Errata disclaimer: This Errata applies to SLG46108 revision YA.

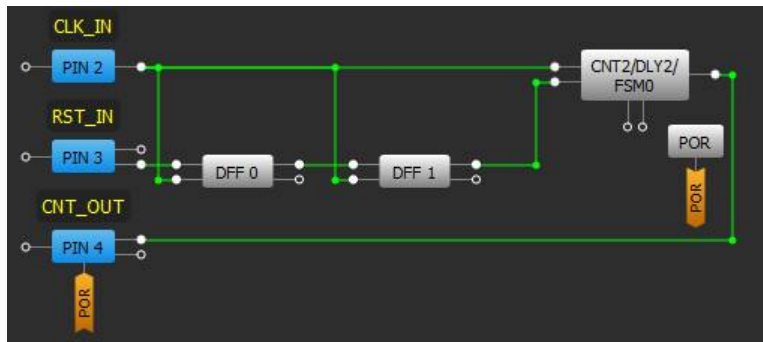
## ISSUE: Incorrect Counter Operation after the Reset

If the Counter Reset is asserted at the same time as a rising clock edge, it is possible that the Counter Data will be reset incorrectly and the counter output may appear faster than expected. This phenomenon appears more often as the clock frequency increases.

- Synchronize the RESET input of the Counter with its CLK using 2 DFF cells as shown in the image below.

### OSC Accuracy vs VDD

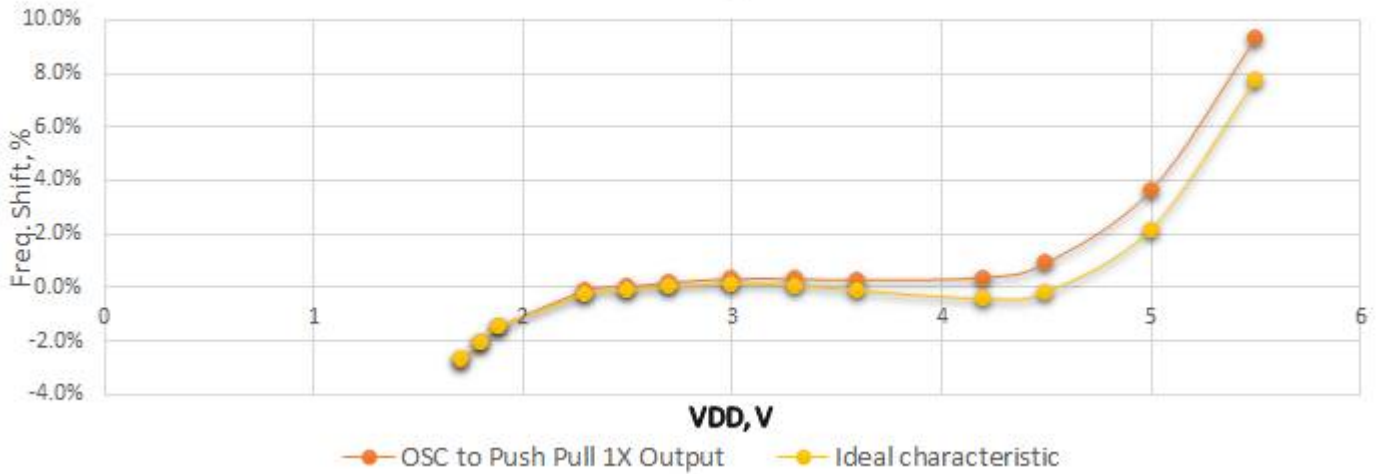
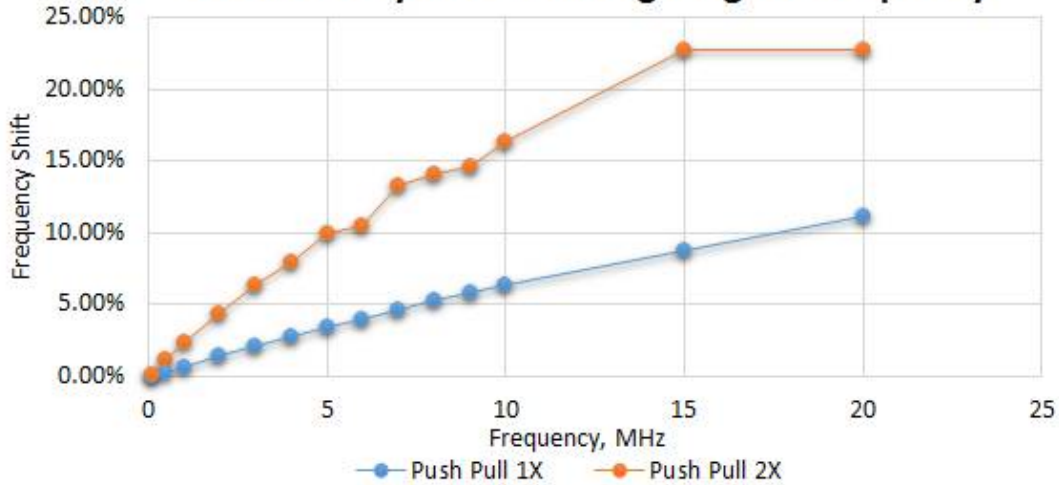
## ISSUE: VDD Noise Influences OSC Variation

While applying some high frequency noise to the VDD, OSC inaccuracy may increase. The same behavior is also present in cases where high frequency switches are outputted from the chip using the Push Pull type driver. See, test results below.

However the issue can be minimized by doing the following:

- Only use frequencies lower than 2 MHz when switching the output
- Do not use parallel PIN connections to output high speed switching signals.
